**City of Biddeford
Historic Preservation Commission**

RE: **Item 4.1: 2025.37 HPC Review** Archetype Architects to revise the design of a previously approved project at 6 and 14 Main Street, Tax Map 71, Lot 10/1 and Tax Map 71 Lot 10/4, respectively, in the MSRD-3 Zone.

Modification Request

Project:
BUILDINGS 19 & 20
PEPPERELL, BIDDEFORD, ME

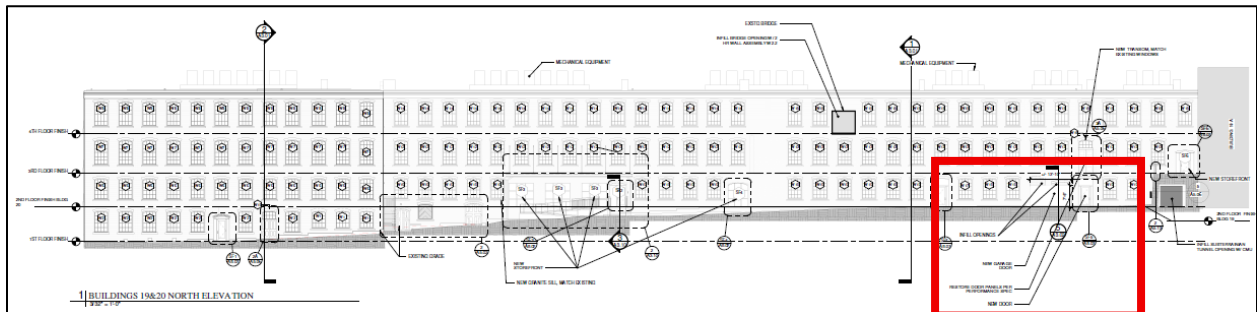
Revisions are shown below. Roof deck and railing, and roof access (stairs, elevator) have been deleted from the design. Other mechanical equipment will remain:

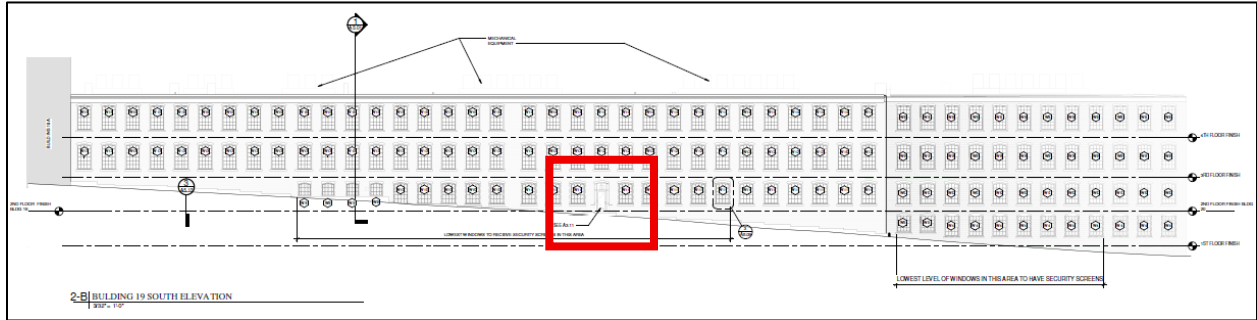
On the same elevation, a new overhead door and new egress door have been added to the design:

An existing dock door and an existing window opening on the North elevation will, together, be modified to accommodate a new overhead door opening. The existing arches will be retained, with the area between the existing arch and the new opening infilled. With a new metal overhead door, this work will slightly change the character of a secondary façade of this building.

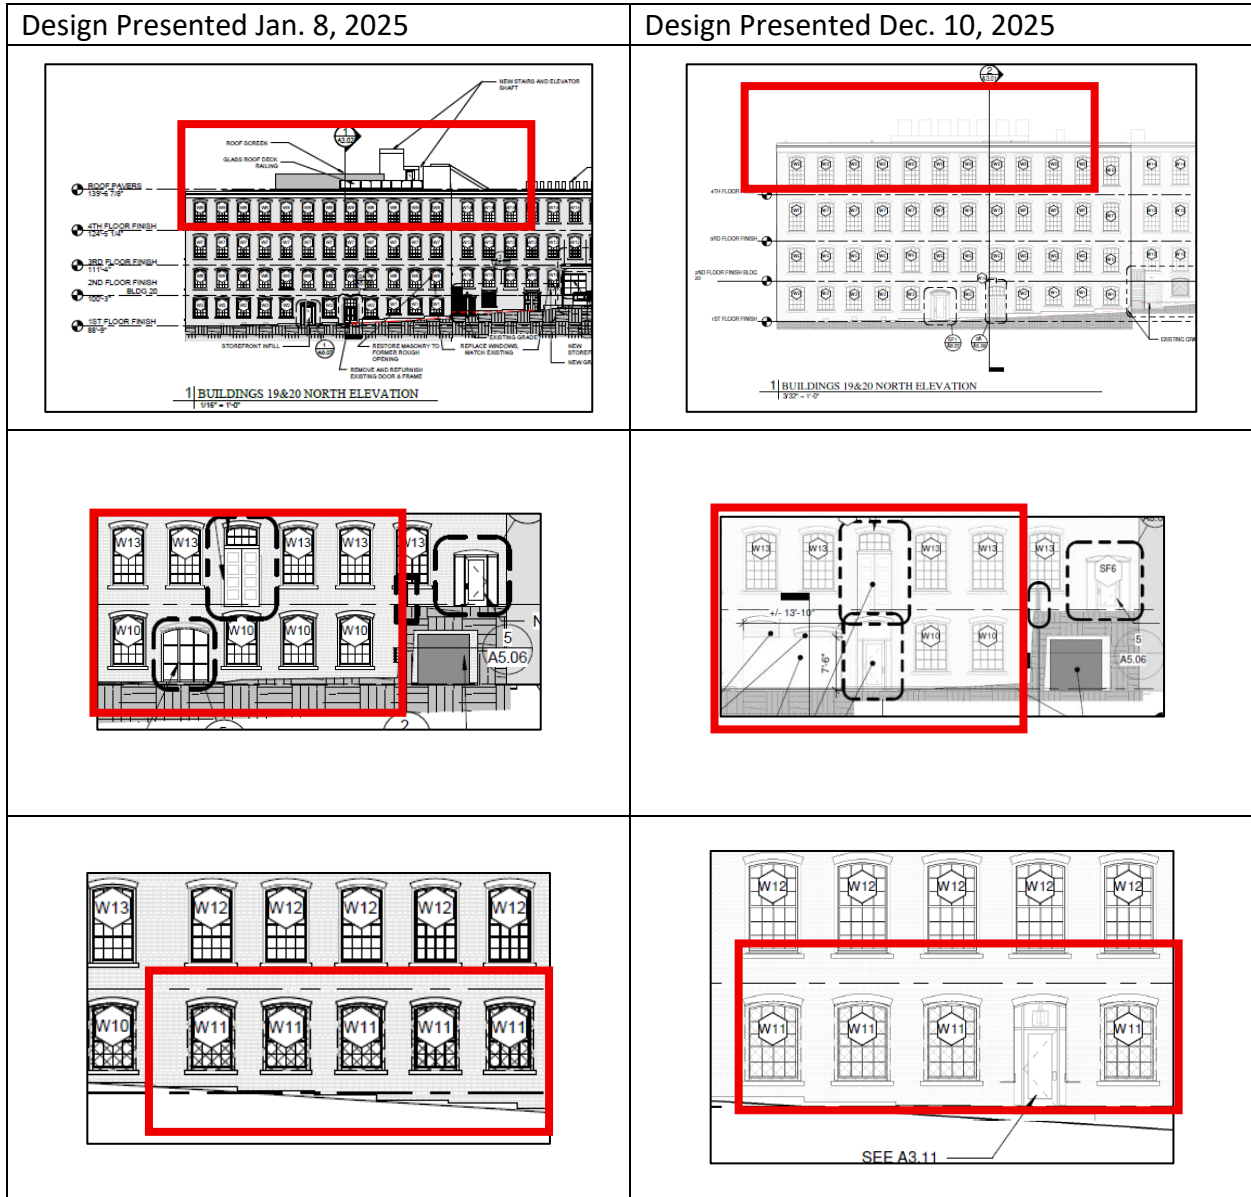
On the South elevation, an existing window opening will become a doorway:

Similarly, on the South elevation, an existing window opening will be enlarged to create a doorway. This new door is simple and scaled appropriately and maintains the character of the primary façade of the building. See images below and other drawings in the agenda packet for details.
